Updated test vectors for 177A

Comment #294, #453

Xiang He, Xuebo Wang
Huawei

Misunderstandings on the scrambler

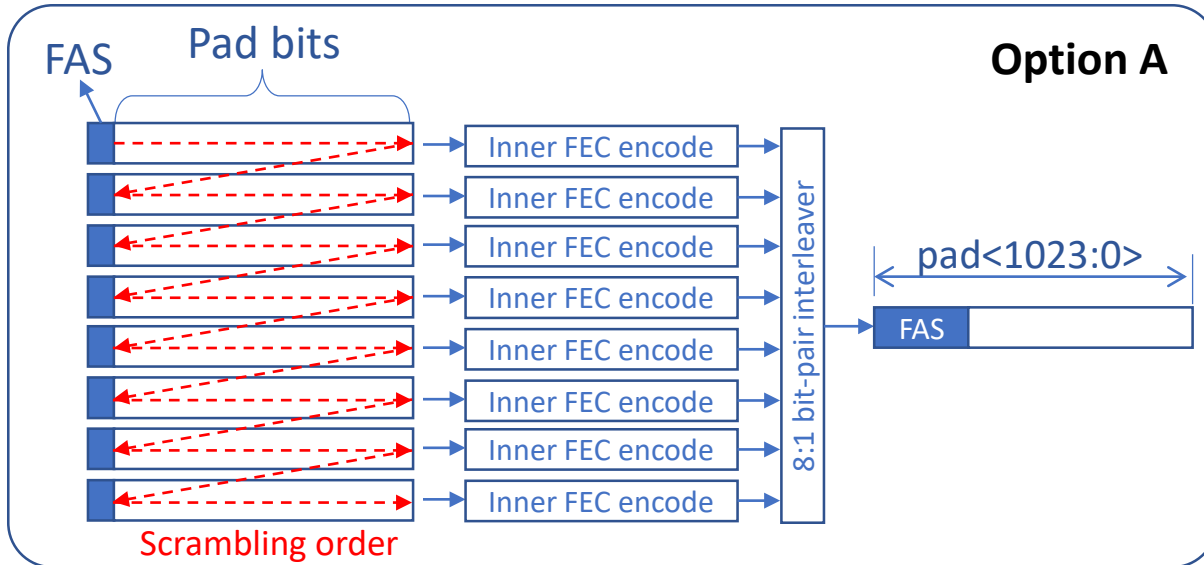
- During discussion how the vectors are generated, we found there were three understandings on how the scrambler is done among different individuals.

- Option C is wrong because pad is not following the same process as normal data (payload).
- Both option A and B can serve the purpose.
 - Option A was the original idea when PRBS13 was proposed, and a match has been confirmed by Nir Levy.
 - Option B is more intuitive and easier to implement.

- Text files can be found at: https://www.ieee802.org/3/dj/public/25_07/he_x_3dj_xxx_2507.7z
 - It was generated using option A in slide 4.
- The test points are following the same definition as in D2.0.
- Depending on how comment #110 is resolved, TP4 and TP5 may be removed.
